#### **ADDENDUM # 02**

Project: Kern Community College District

Bakersfield College Combined Gym & Fieldhouse - Pool Equipment Building

Date: October 15, 2025

PLAN - POWER JOB NUMBER: 23024.02

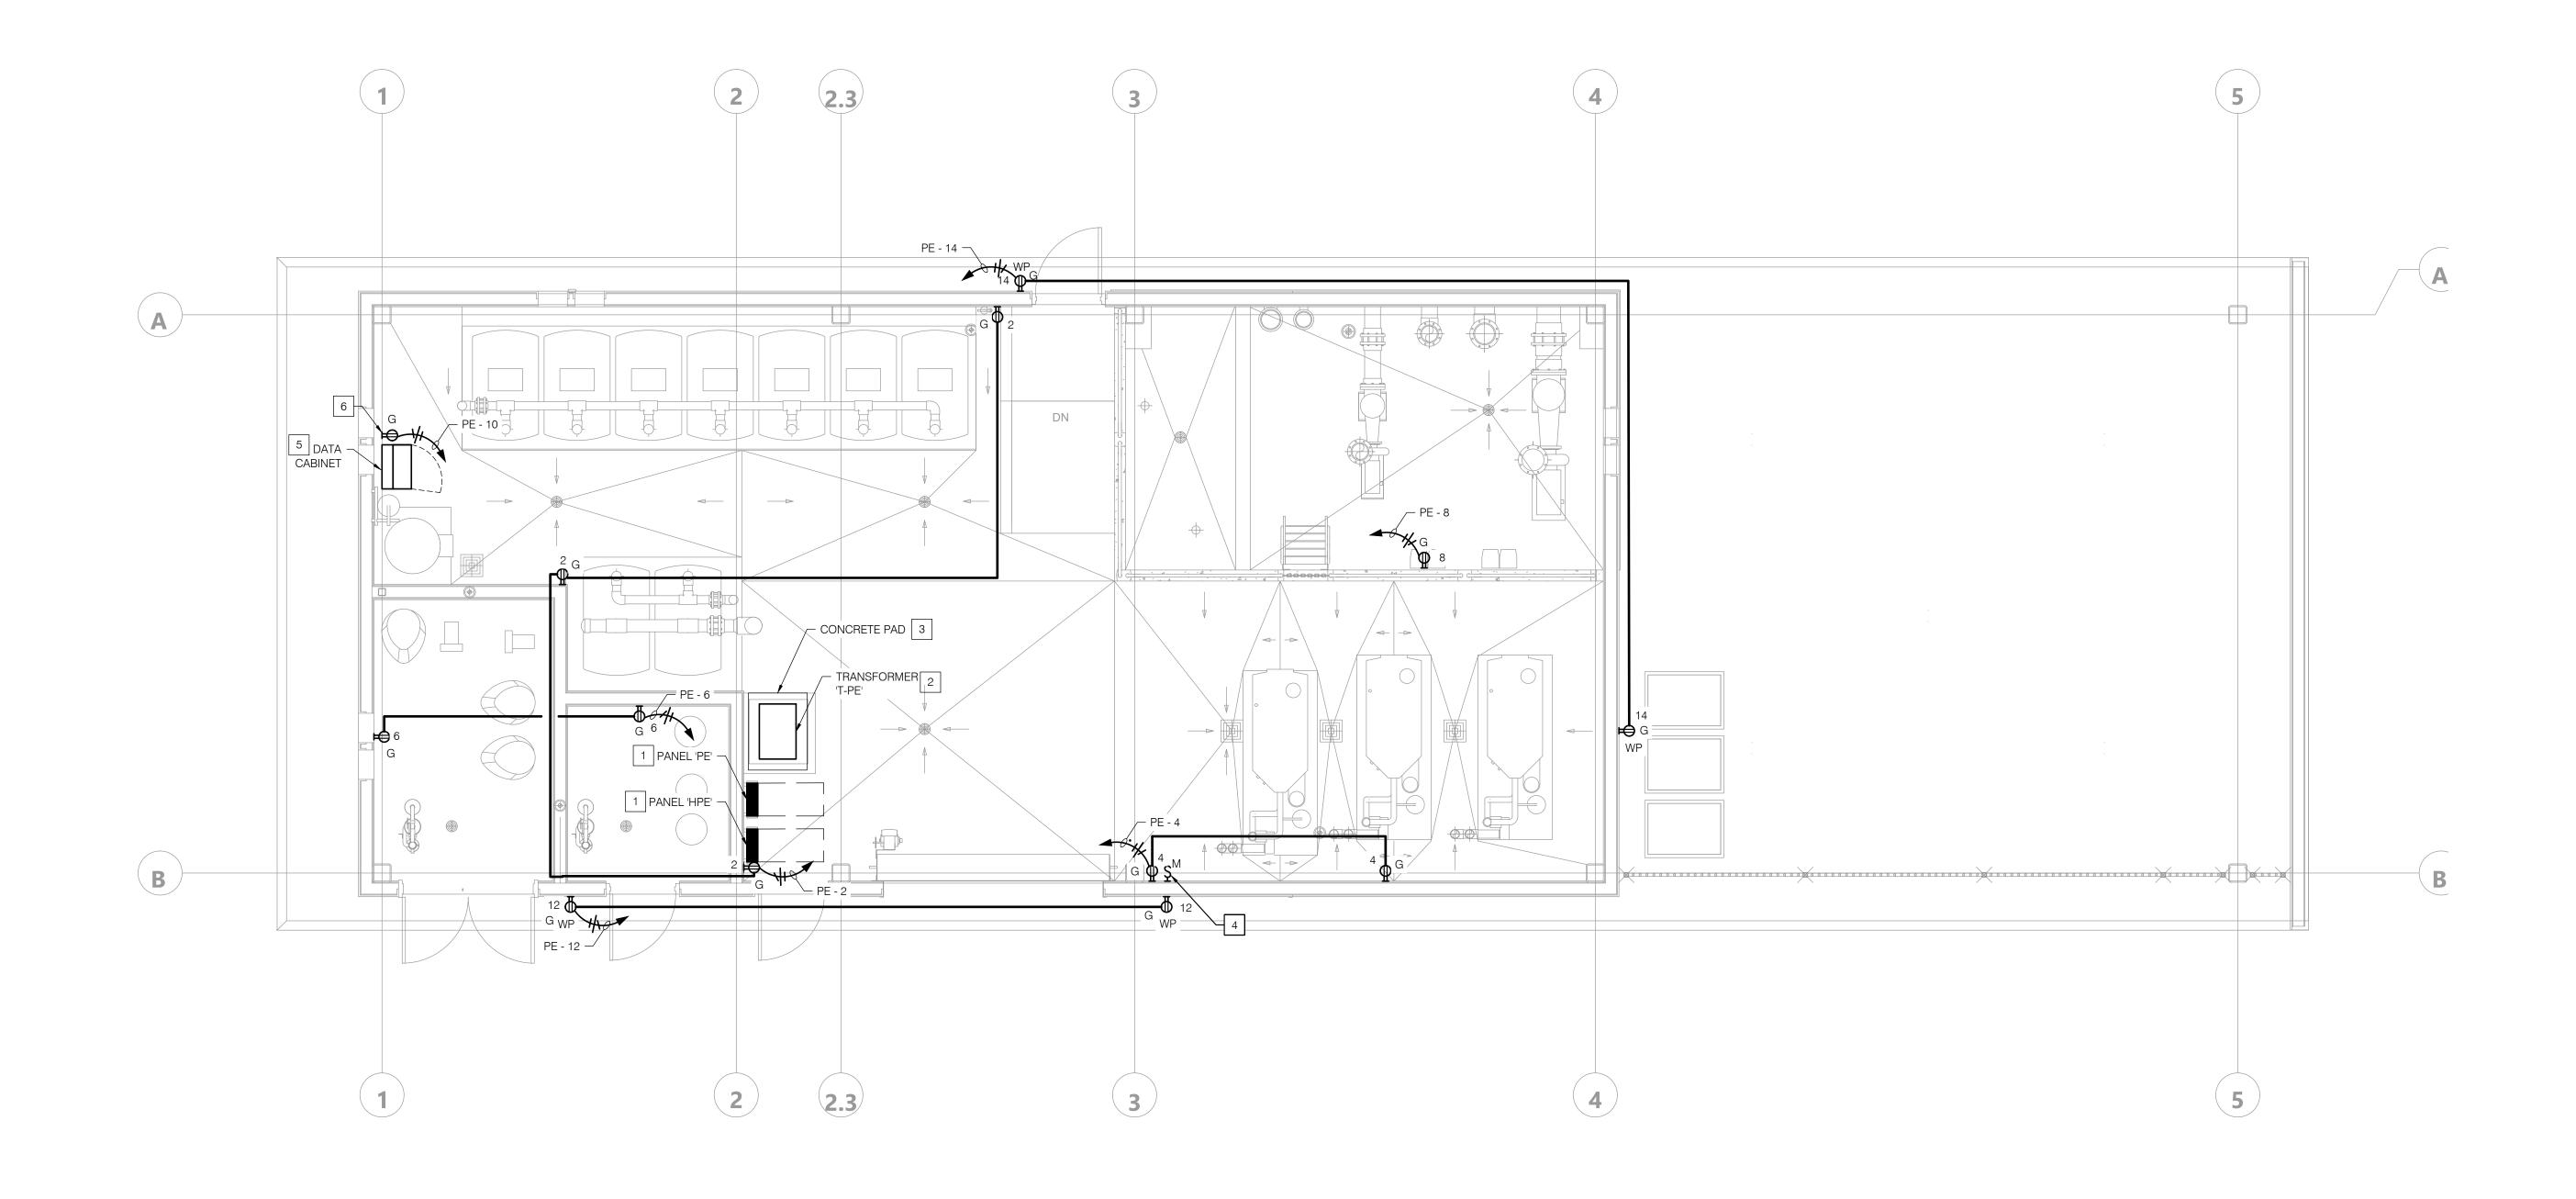
ITEM#	QUESTIONS / COMMENTS
	QUESTIONO / COMMILITIO
001	Electrical sheets E101, E201, E202-P and E-203 are missing the title block and page number. Please provide updated sheets with page name and number for reference.
002	Electrical Single Line Diagram sheet E501 is blank. Please provide updated sheet with missing information.
003	Specification section 05 12 00 - Structural Steel, Section 1.6 Quality Assurance, item A. requires steel fabricator to be an AISC certified shop (LA City Approved Shop). Please confirm if this requirement can be deleted as this currently limits our local contractor market in Kern County.
004	Article 58 Insurance Requirements, Section 5-A regarding Course of Construction (COC) Builders Risk Insurance states: "When required by Owner"  Please confirm if General Contractors are to include Builders Risk Insurance for this project.
005	Structural plans call for all steel exposed to weather to be galvanized. Does this include all steel within the building that can still be considered exposed to weather? Please clarify what steel is to be galvanized.

Bakersfield College Combined Gym & PROJECT: RFI NO.: PB-002 Fieldhouse - Pool Equipment Building **OWNER:** Kern Community College District DATE: 10/03/2025 **CONTRACTOR:** Black/Hall Construction, Inc. P.O. Box 445 Taft, CA 93268 **DRAWING REFERENCE: SPECIFICATION REFERENCE: BRIEF TITLE: Pool Equipment Notes DESCRIPTION OF CLARIFICATION REQUIRED (attach sheets as necessary):** Please provide notes 1-11 on pool equipment building electrical site plan. Plans are showing note callouts, but no notes are shown.

001 The missing information has been addressed and is included on the revised sheets provided in Addendum 2.

The missing information has been addressed and is included on the revised sheets provided in Addendum 2.

PULLBOX 'PB-1'

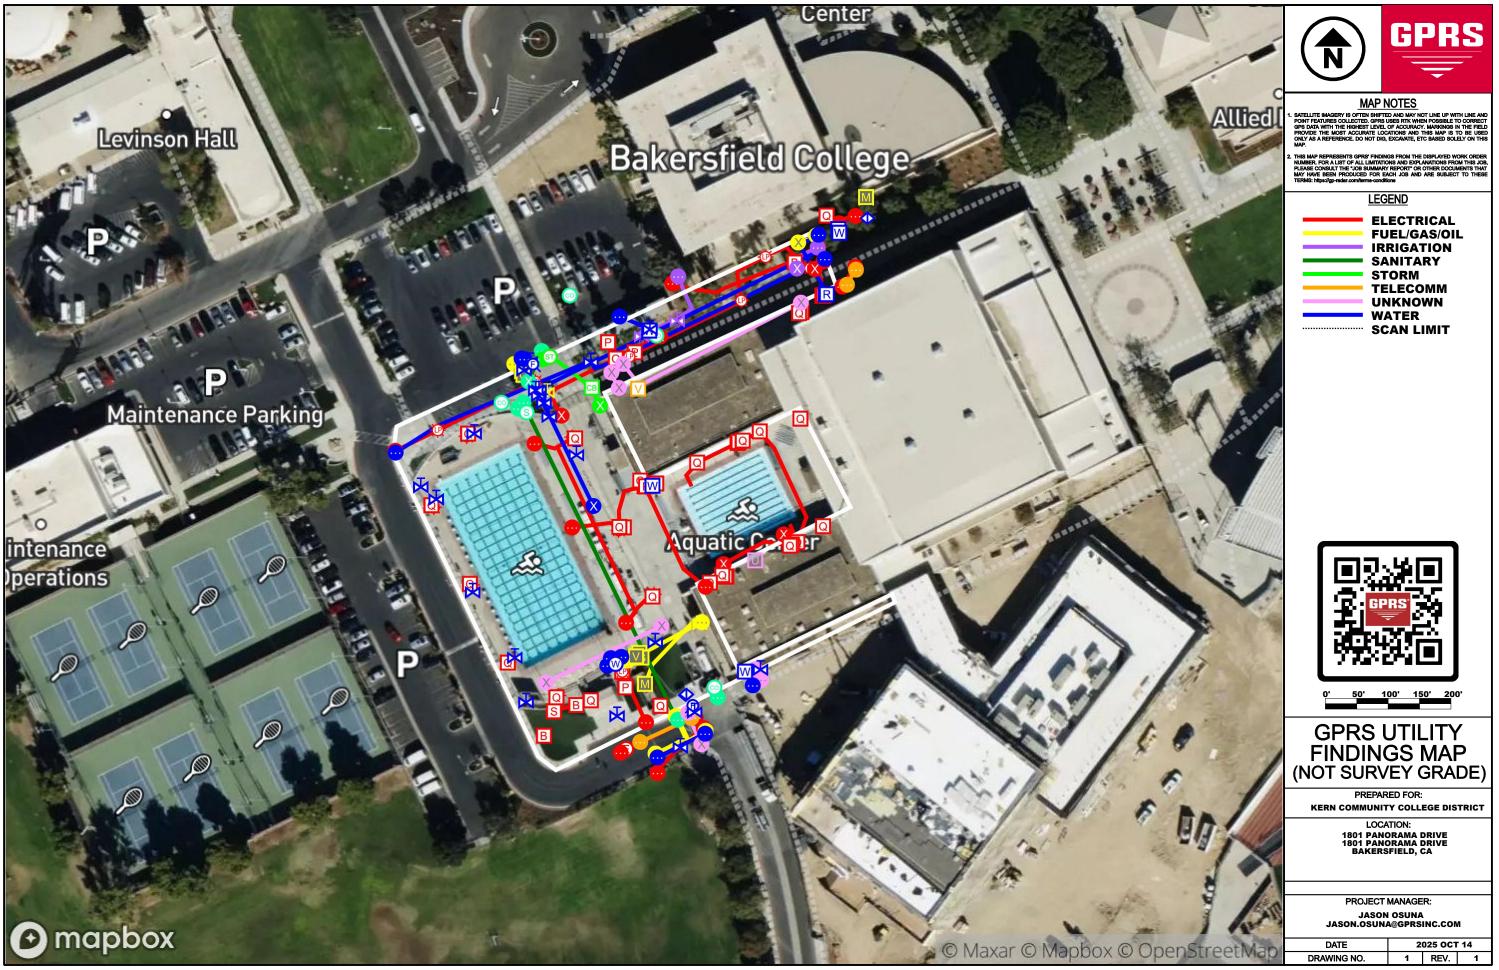
ITEM#	QUESTIONS / COMMENTS
2.01	Please provide the scales for sheets E-101 and E-201.
2.02	Please clarify and circuits going though E-021 and E-022 that will need to be rerouted and their sources of power. Also, please clarify the types and sizes of electrical equipment that are in these areas that need to be removed.
